RAPID INFILTRATION BASIN (RIB) EXPANSION

ADDENDUM NO. 3

DATE: May 19, 2026

Bid Number: 142173578

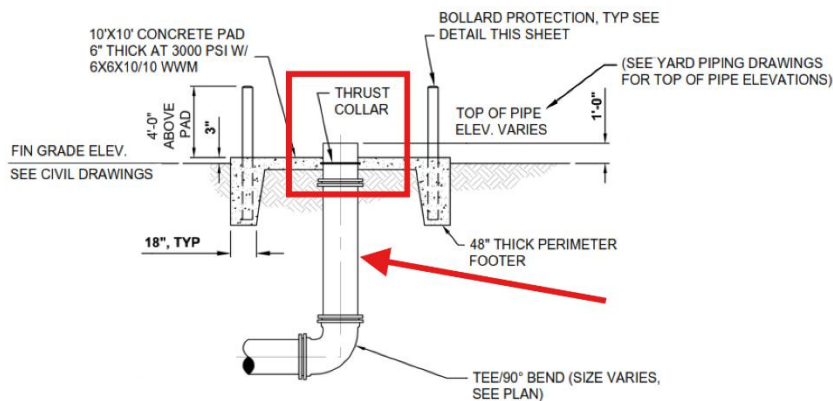
40. Valve Type Discrepancy: Bid Form Item #41 indicates a 16-inch BFV MOV FLG, while plan sheet C03.06 references a 16-inch Gate Valve with Motor Actuation (see referenced snippet). Please clarify which is correct.

Response: Sheet C03.06 is correct. It should be a gate valve. See revised Bid Form. The above grade assembly is captured as a LS item.

RIB DISCHARGE DETAIL
N.T.S.

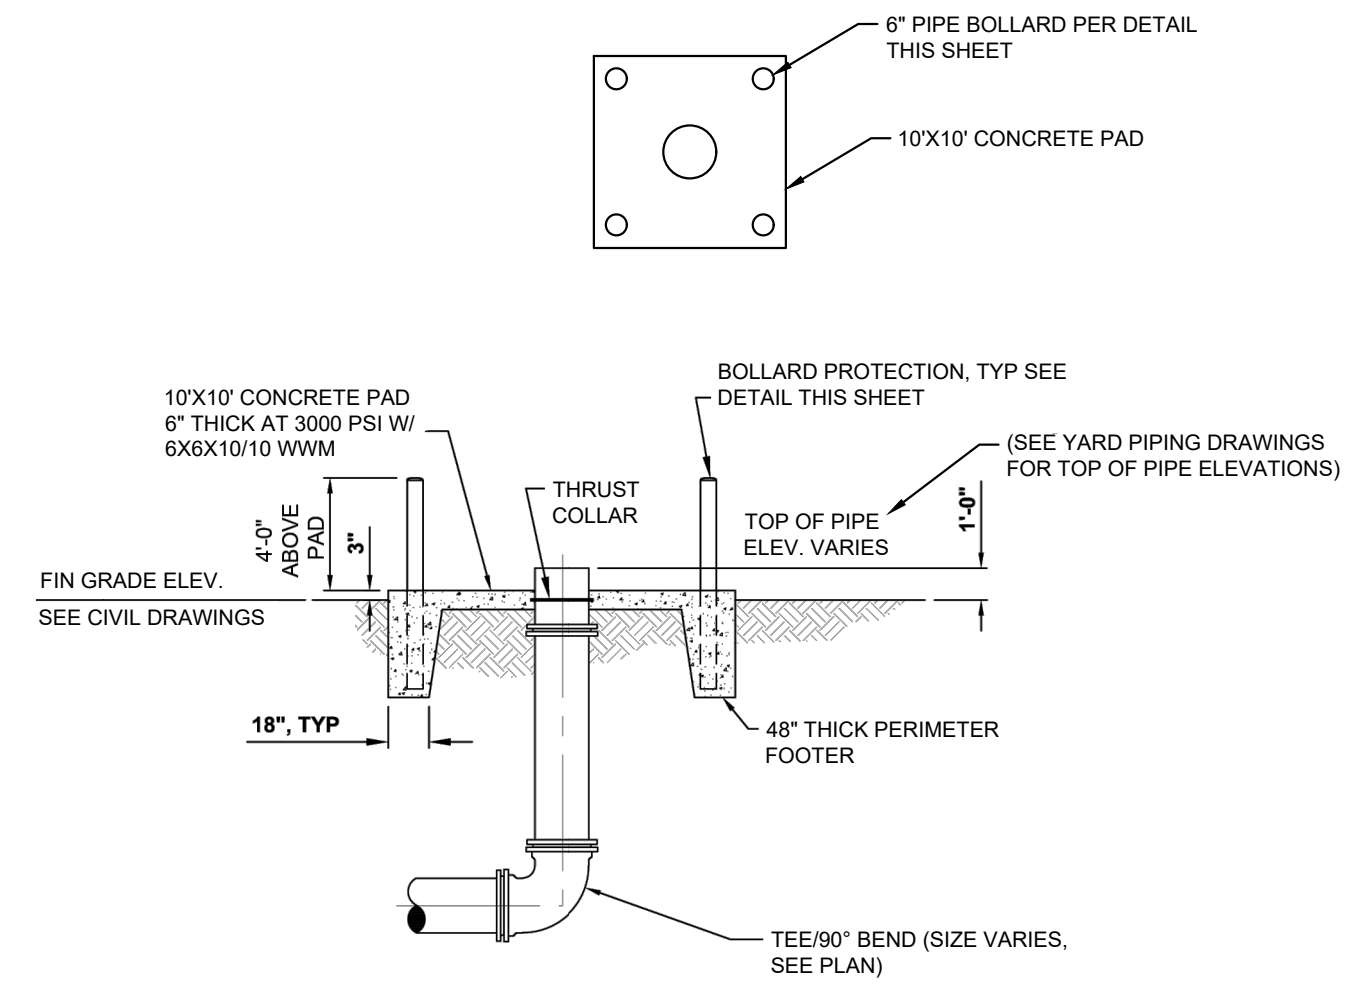
41. Rib Discharge Detail: Please confirm if the item marked with the red arrow is a Flange × Plain End Ductile Iron Pipe, and if the item marked with the red square is also a Flange × Plain End Ductile Iron Pipe. Please advise if they are different.

Response: Standard detail just requires a thrust collar. Depending on length if an extra piece of pipe is required it could be installed as two PExFE pieces of pipe or two PExPE spool pieces that are connected by a ductile iron MJ Coupling.

CONCRETE FILLED BOLLARD DETAIL

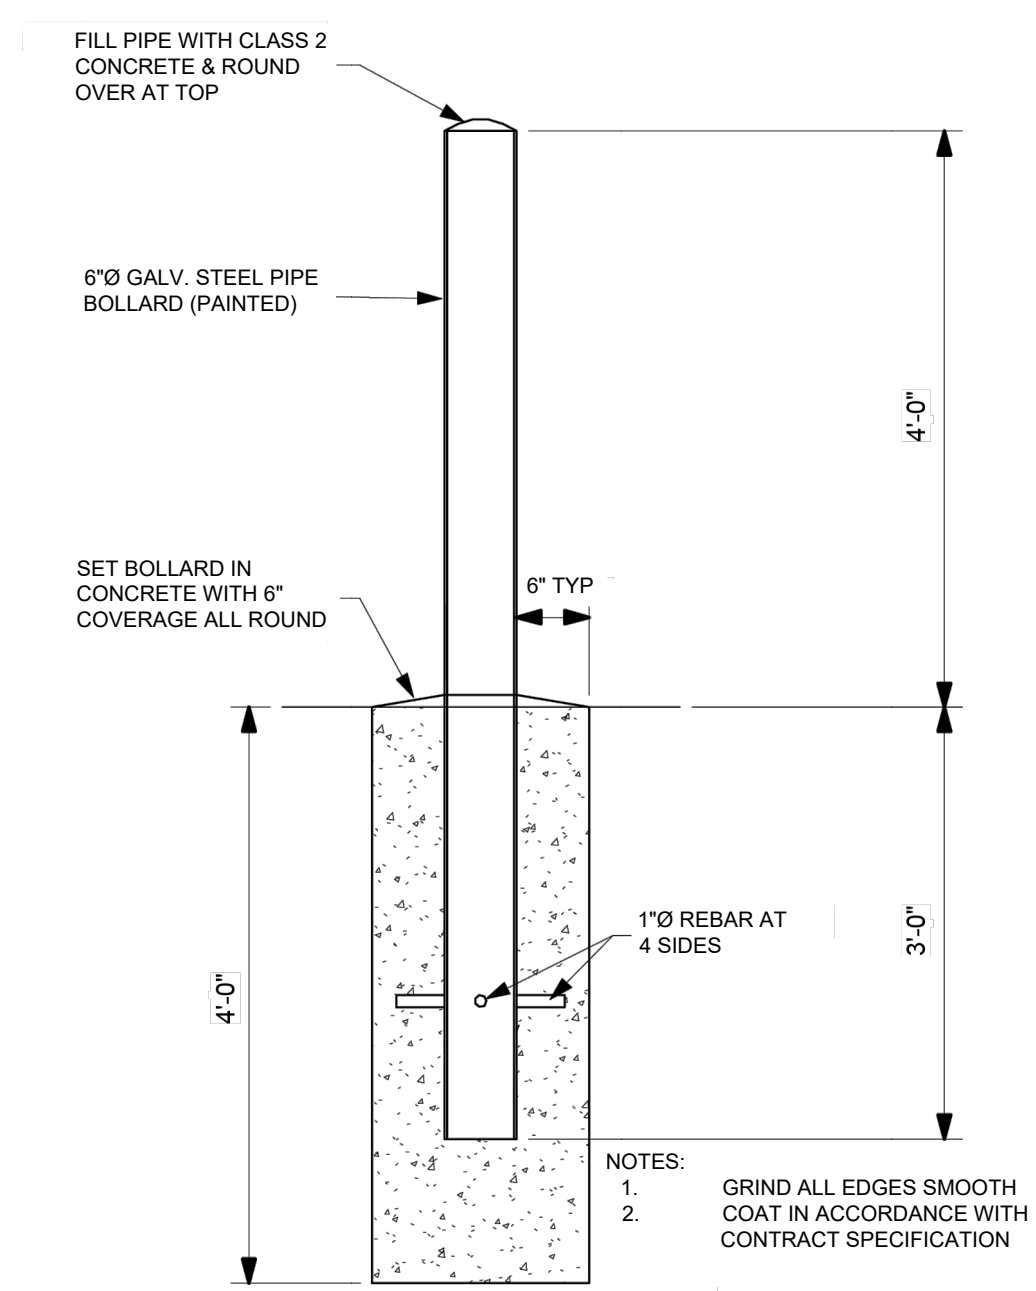
42. How many bollards per column?

Response: 4 bollards per RIB discharge detail
